RELIEF AND RECONSTRUCTION  
FUNDED WORK AT MOSUL DAM  
MOSUL, IRAQ

**SIGIR PA-07-105**  
**OCTOBER 29, 2007**

SUBJECT: Report on Relief and Reconstruction Funded Work at Mosul Dam, Iraq  
(Report Number SIGIR PA-07-105)

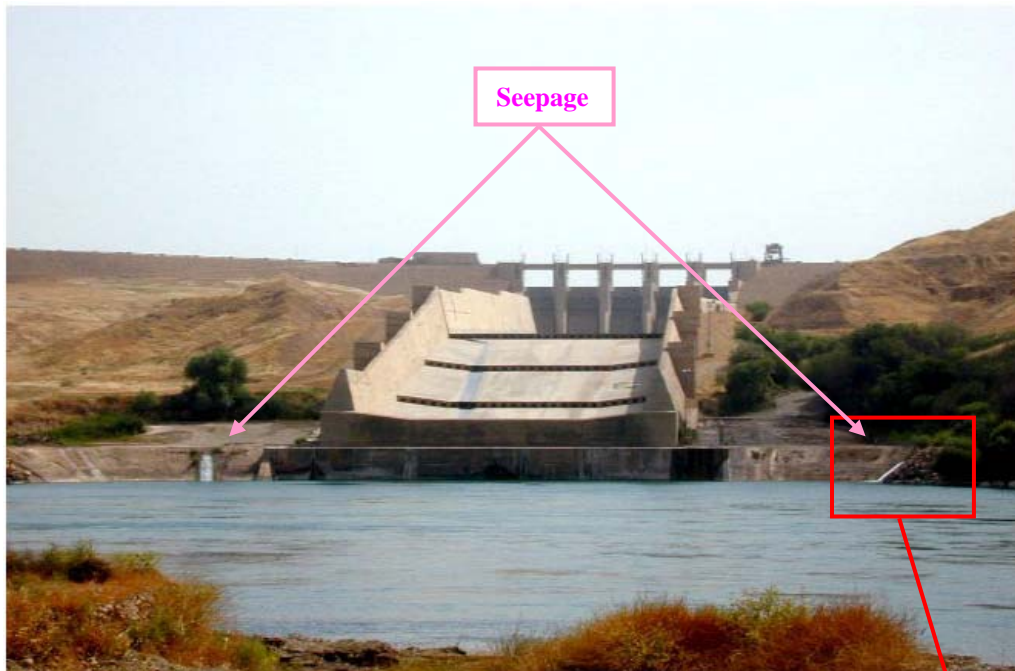
**Page 9, Figure 6.** We are not aware of seepage points that pass through the main embankment. Field observations did not identify seepage points in the main body of the dam as shown in the figure. Please either remove the figure or provide reference to the source of the figure and the analysis used to identify these seepage points.

**Figure 6. Illustrative example of the Mosul Dam’s grouting program aimed at filling voids and cavities from the gallery (Figure courtesy of USACE)**

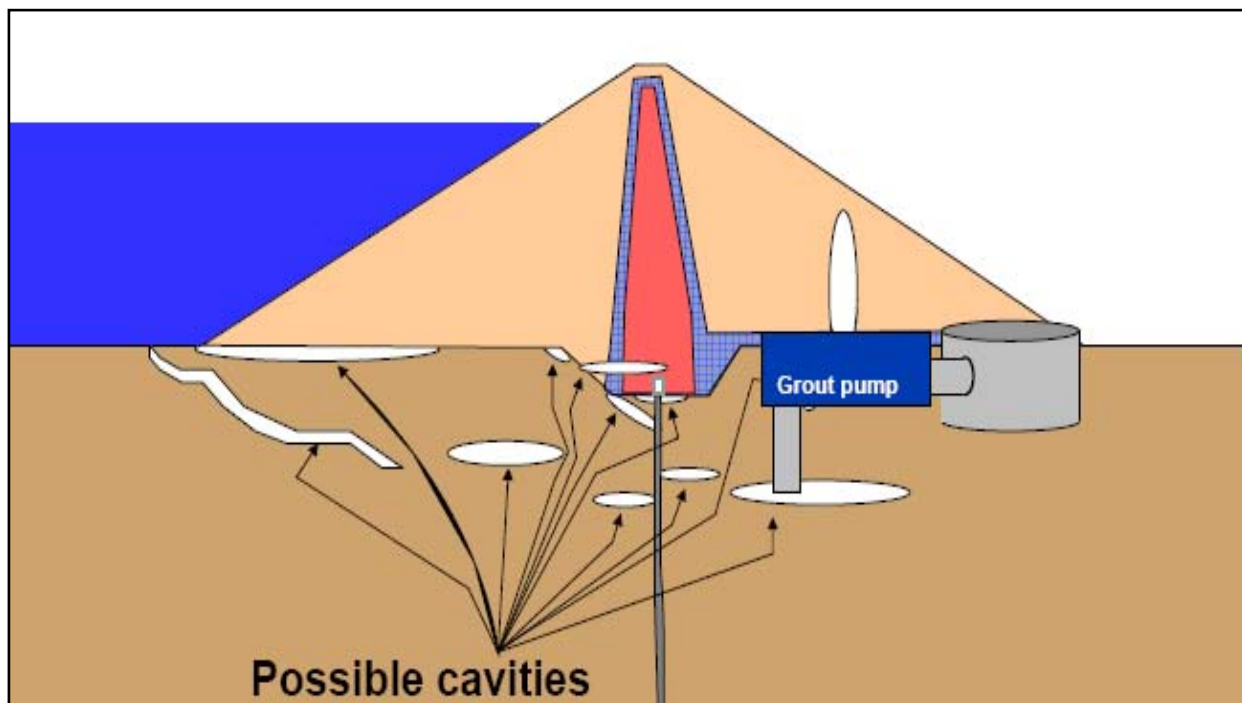
**Page 10, Figure 7.** Mosul dam engineers do not have means of “filling cavities” away from the grouting gallery. Figure 7 shows a grout pump filling a cavity downstream from the gallery; there is no means available to achieve this. Grouting can only occur from the grouting gallery. Suggest removing this figure.

Figure 12. Contractor's design drawing for 30-m<sup>3</sup>/hour concrete-mixing plant

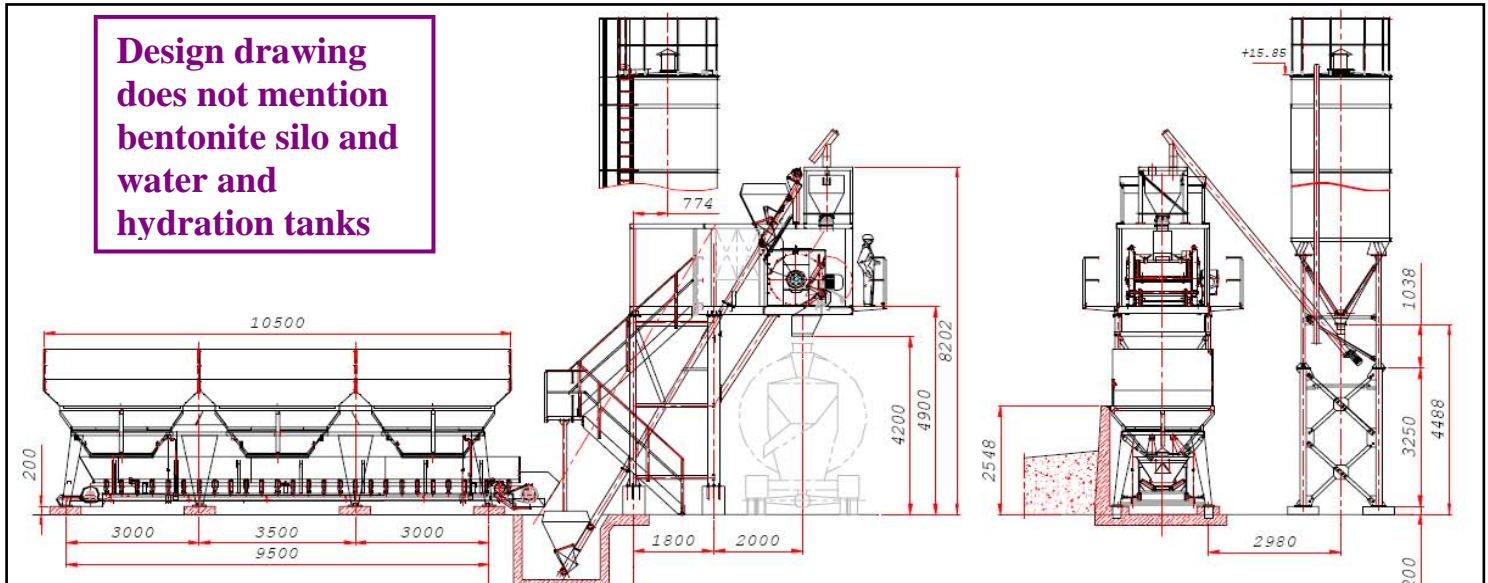
GRD provided the contractor's design submittals for the two sizes of grout-mixing plants (i.e., 30-m<sup>3</sup>/hour and 100-m<sup>3</sup>/hour), which we reviewed. For the 30-m<sup>3</sup>/hour grout-mixing plants, our review of the design drawings concluded that the contractor was clearly offering concrete-mixing plants, not grout-mixing plants (Figures 12 and 13). Grout mixing plants require a bentonite silo and water and hydration tanks, associated weighing and measuring devices, additional pumps and motors, which were not included in the design drawings.

Figure 13. Contractor's design drawing for 100-m<sup>3</sup>/hour concrete-mixing plant

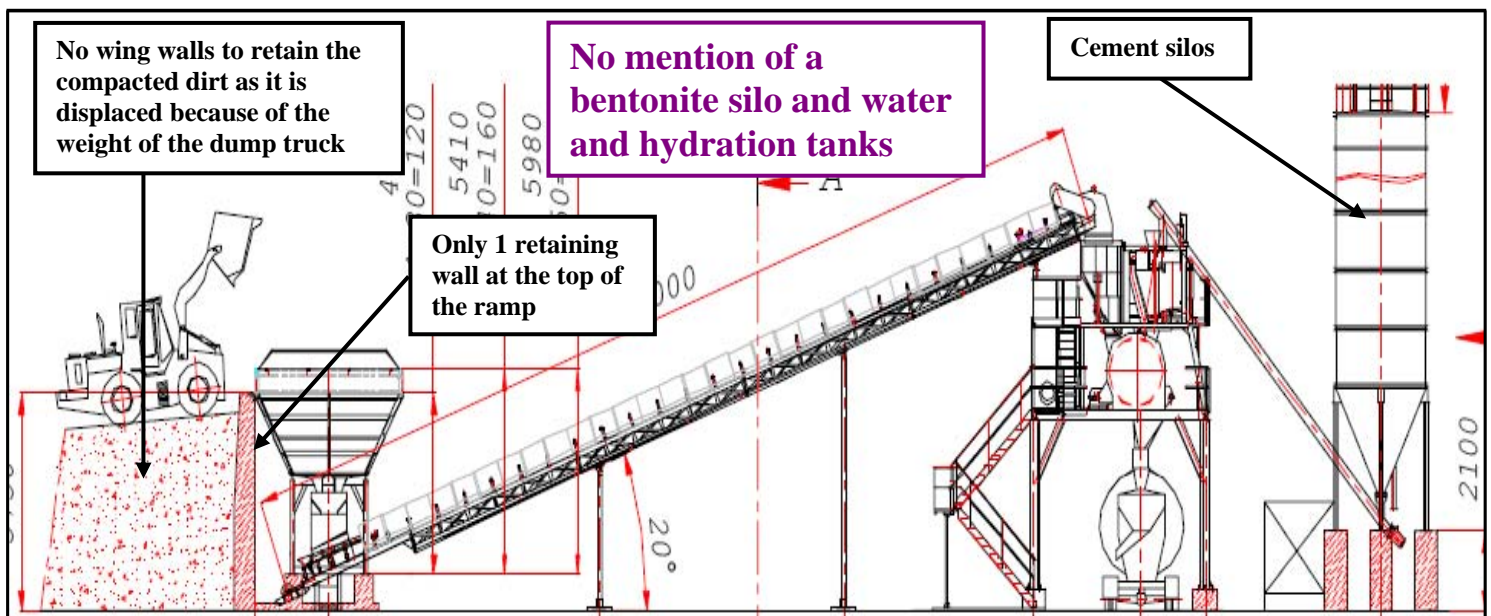
In our opinion, the 100-m<sup>3</sup>/hour mixing plant design submittal also clearly indicated the contractor was offering a concrete-mixing plant, not a grout-mixing plant (Figure 15). The design submittal lacked a bentonite silo, water and hydration tanks, associated weighing and measuring devices, and additional pumps and motors, which are essential for a grout-mixing plant (Figure 13).

The July 2006 CH2MHill/Parsons’ memorandum did not mention the 100-m<sup>3</sup>/hour grout-mixing plant. The contract file lacked any documentation regarding how the concrete-mixing plant was reviewed and approved instead of the required grout-mixing plant. It appears that for the 100-m<sup>3</sup>/hour grout-mixing plant design submittal, the EC also did not “notice” the contractor’s submittal offer was for a concrete-mixing plant, not a grout-mixing plant. In addition, the EC did not recognize the contractor’s design submittal lacked side retaining walls (i.e. wing

walls) for the loading ramp (Figure 13). The wing walls are crucial for the use of the loading ramp because without them, when the full dump truck drives up the ramp, the compacted dirt will disperse under the truck's weight resulting in the truck not being able to reach the hoppers to unload the materials.

Figure 16. Top view of four stationary silos

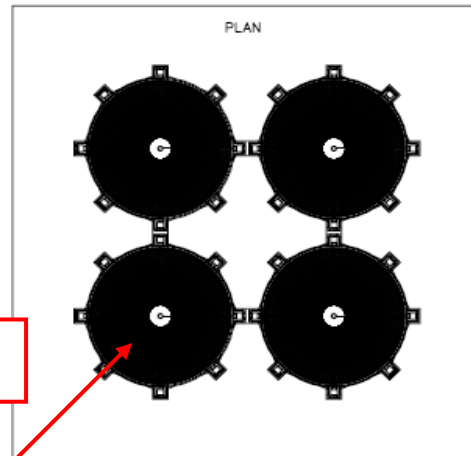
The "Plans and View [sic]" design submittal provided multiple views of the finished stationary silo (Figures 16 and 17). According to the design drawings, each silo was to be approximately 120 feet high (from the base to the top). After thoroughly reviewing all available design drawings, we found the designs lacked significant details, such as lateral bracing support for the entire height of the silos (Figure 19), notes for the thread size, length, washer size, base plate requirement, and torque (for the foundations bolts – Figures 18-21), how the MWR personnel will deposit cement into the silo, and safety concerns. The lateral bracing supports for the entire height of each silo are important in order to keep each silo in its intended vertical position while allowing the load to transfer to the mat foundation during the cement filling process. The proportion of the silos is very large, since the height to diameter ratio is almost 6 (Figure 17), which could result in the silos overturning. According to an internal GRD document, the "standard practice is to resist overturning by a ratio of 1.5." A consulting engineer for GRD stated the silos looked like an "inverted pendulum." Further, detailed information for the foundation bolts is critical, since the foundation bolts will be required to counter all gravitational forces that would cause the silo to tip over, under most conditions. Further, since the opening to fill each silo is located at the top (120 feet high), for safety reasons, we are concerned that the contractor's designs did not include a safety ladder to climb or a safety bar and railing at the top (Figure 17). Additionally, no secure walkway with safety railings is shown to connect all silos at the top.

Finally, the awarded contract required the stationary silos to have a "control room." The design drawings did not mention the use of a control room.

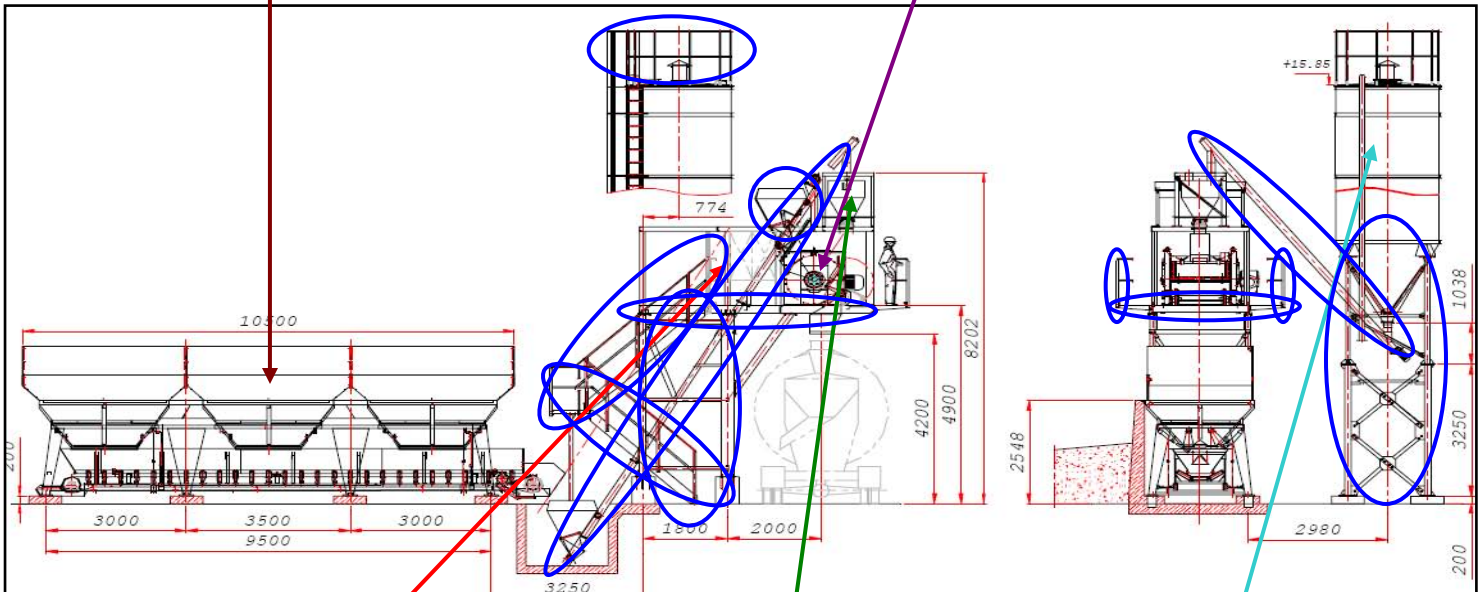
On 12 September 2007, we observed the pieces of an unassembled 30-m<sup>3</sup>/hour concrete-mixing plant (Site Photos 12-16). After reviewing the contractor's design submittals for the 30-m<sup>3</sup>/hour concrete-mixing plant (Figure 27), we attempted to determine if all the mixing plant pieces were delivered. The available pieces did not appear to be adequate to fully construct either a grout or concrete-mixing plant. It appeared that several items were missing, such as screw conveyor, pipes, and air compressor. Considering the contractor used one of the four silos dedicated for the 30-m<sup>3</sup>/hour mixing plants, it will not be possible to construct both mixing plants.
